Field Report

Field Report No.: 15											
SP&A Project No: 22.331					Report Date: 12-06-2024		Time: 9:30AM				
Project: Gales Ferry School (Name & Location) 1854 CT-12 Gales Ferry, CT 06335											
General Contractor: The Imperial Company, Inc.											
Weather					Site Conditions			Day of Week			
☐ Temp. Range: 33°					☒ Clear			☐ Dusty			
☐ Clear ☒ Rain ☐ Foggy ☐ Warm					☐ Muddy			☐ Windy			
☐ Overcast ☐ Snow ☐ Cold ☐ Hot					☐ Other			☐ Monday ☐ Thursday			
								☐ Tuesday ☒ Friday			
								☐ Wednesday ☐ Saturday			
Type of Work Observed Being Performed											
1	☐	Site work	7	☐	General Trades/Drywall	13	☐	Specialties/ Food Service	19	☐	Sprinkler
2	☐	Demolition	8	☐	Windows & Doors	14	☐	Elevators	20	☒	Finish metal
3	☐	Concrete	9	☐	Roofing	15	☐	Plumbing	21	☐	Iron workers
4	☐	Masonry	10	☐	Flooring	16	☐	HVAC	22	☐	Tester (Tri-state)
5	☐	Steel/Misc. Metals	11	☐	Pool	17	☐	Electrical	23	☐	Audio Vis/Low Volt

Roof D – Roof D installation tentatively scheduled to continue work 12/21 (see attached tentative schedule)

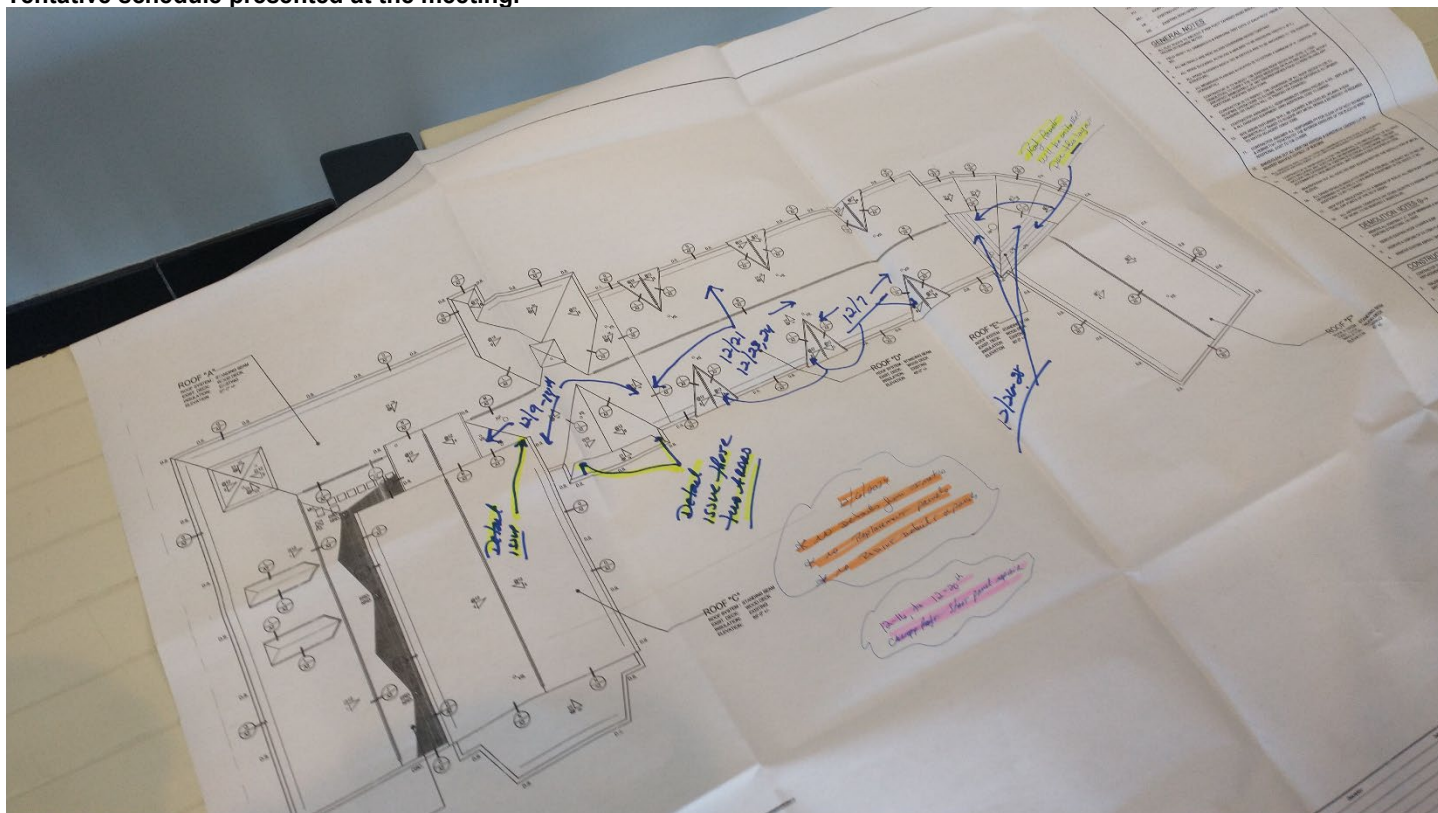
Roof D – Roof D installation tentatively scheduled to continue work 12/21 (see attached tentative schedule)
